Environmental Minor Project Refinement Form

Project Name: West of Devers Upgrade Project Request Prepared By: Sylvia Granados

Date Approval Required: February 18, 2021 Variance Request No.: 44

Southern California Edison
West of Devers Upgrade Project
Proposed Work Area
MPR #44

FIGURE 1

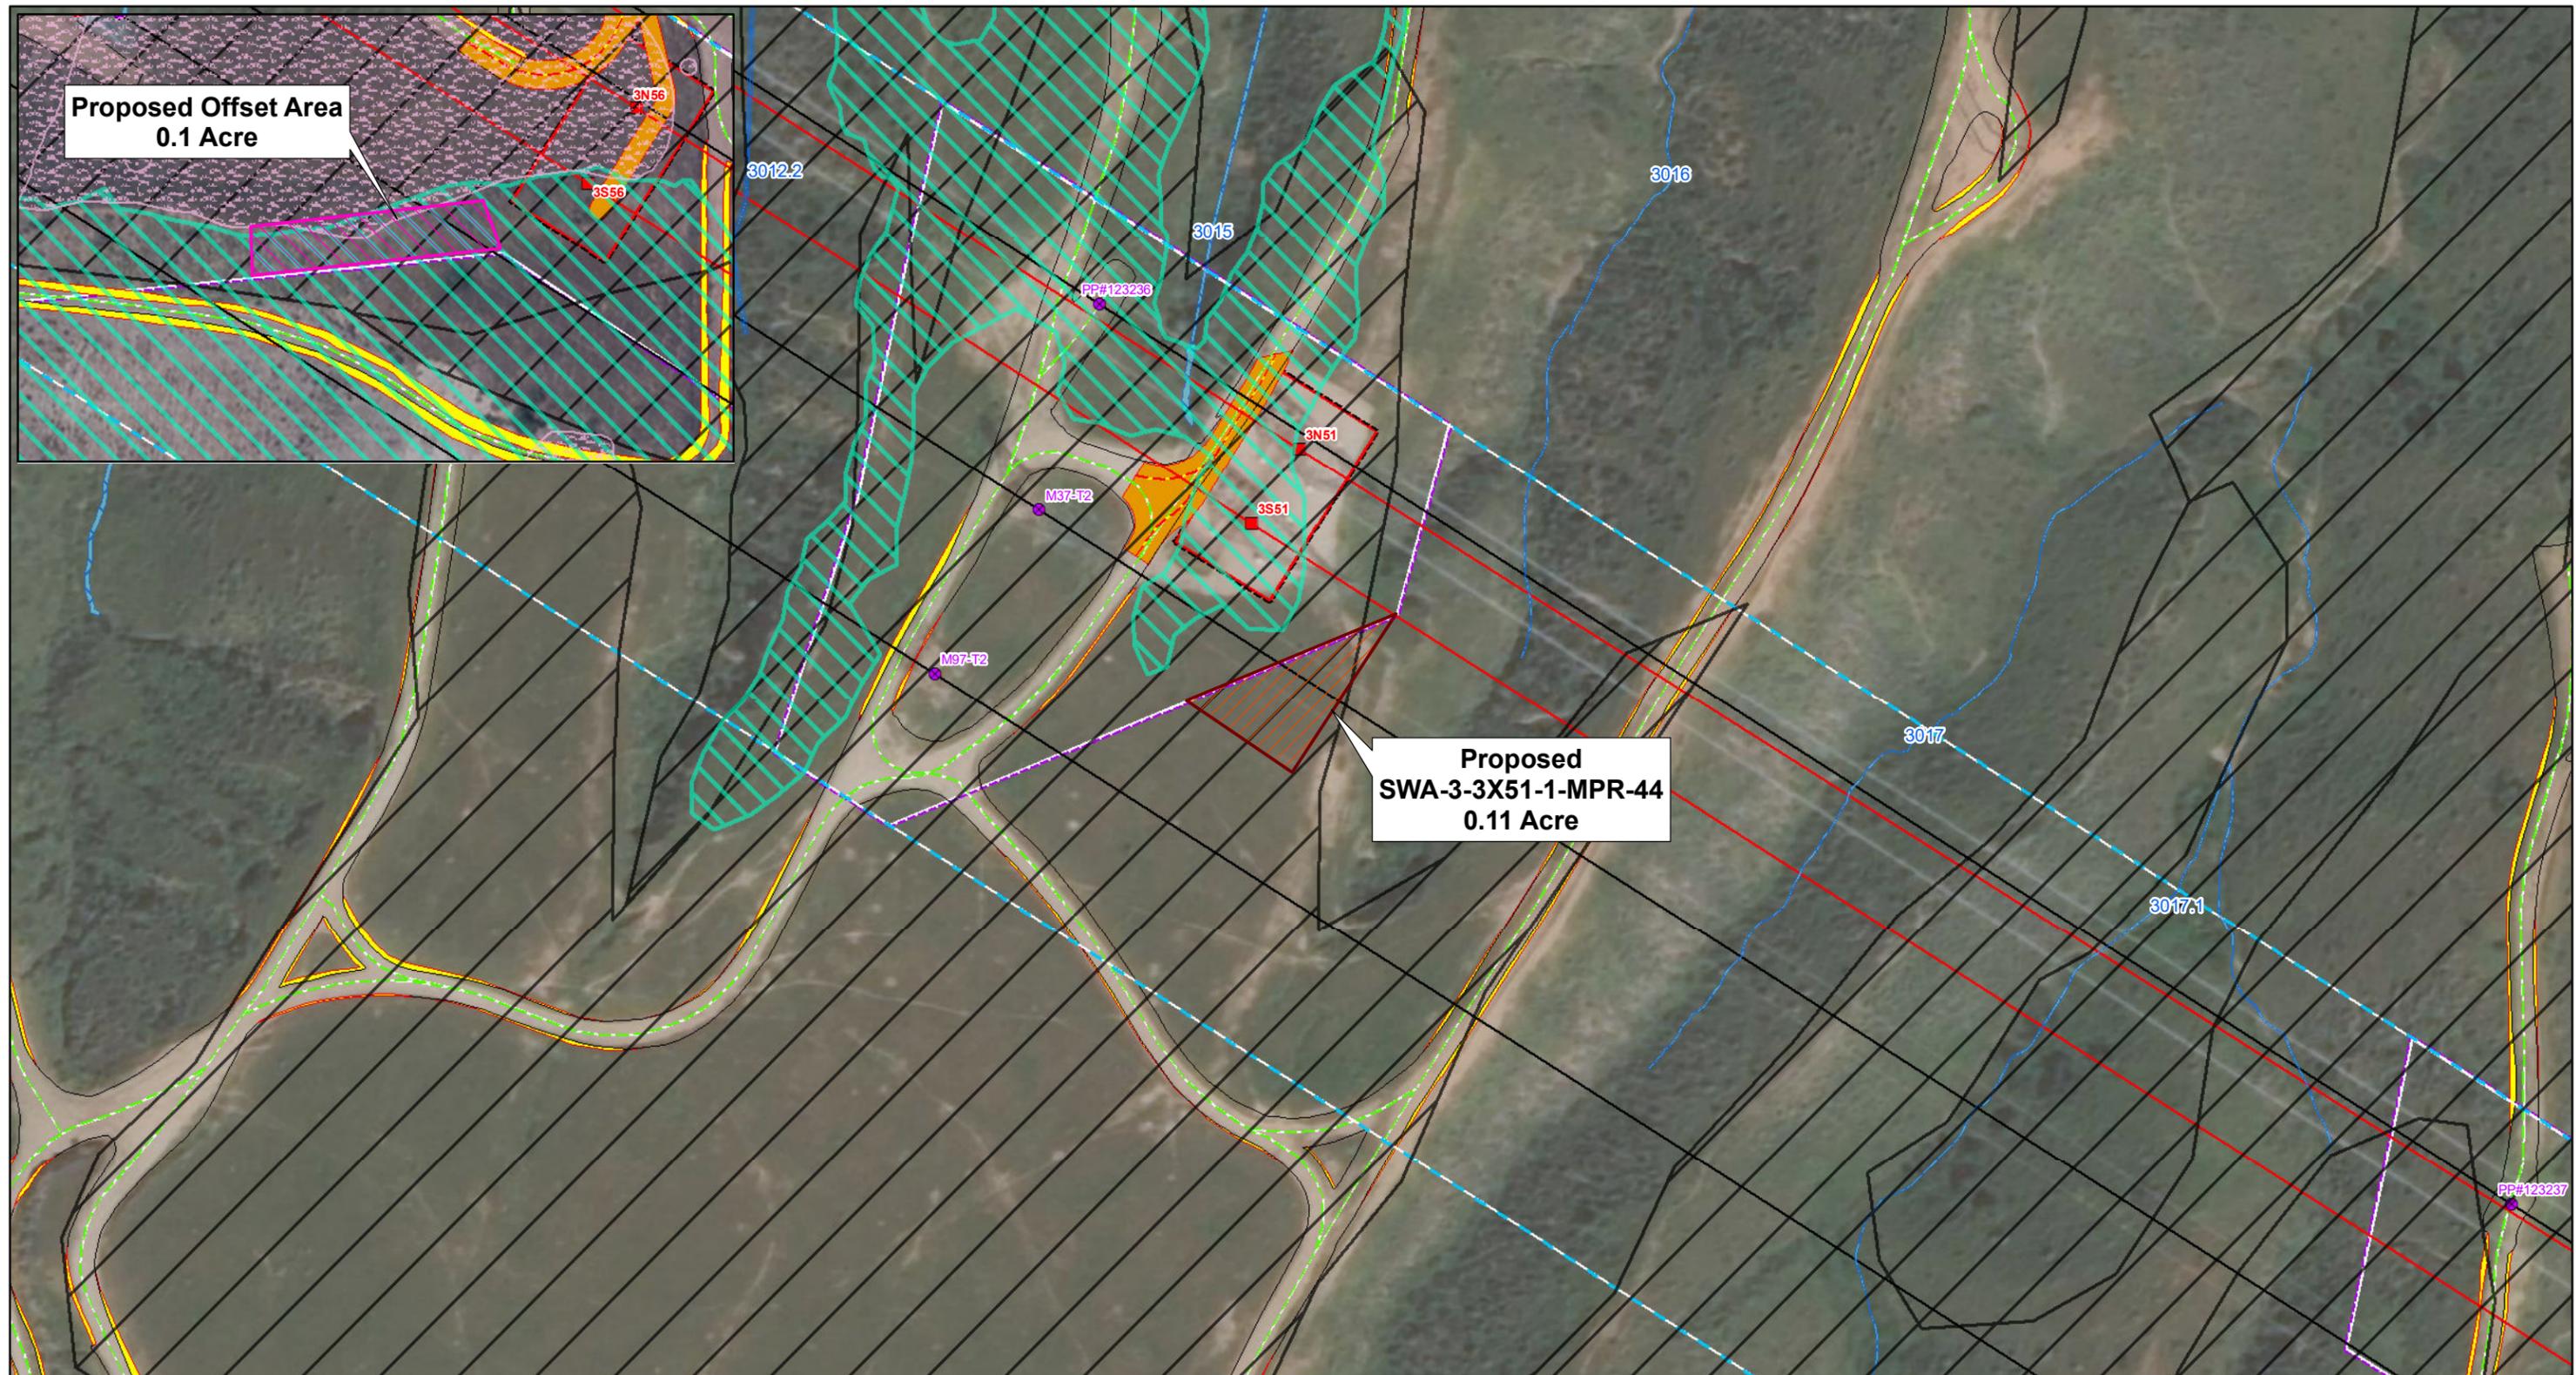
A new temporary 0.11 acre work area, adjacent to the southeast side of Supersite 3X51, is required to safely stage material and equipment required during wire wreck-out activities associated with M37-T2.

The new temporary work area will result in approximately 0.11 acre of temporarily impacted private property located within the SCE transmission line right-of-way, consisting of 0.102 acre grassland/forbland and 0.008 acre Coastal Sage Scrub.
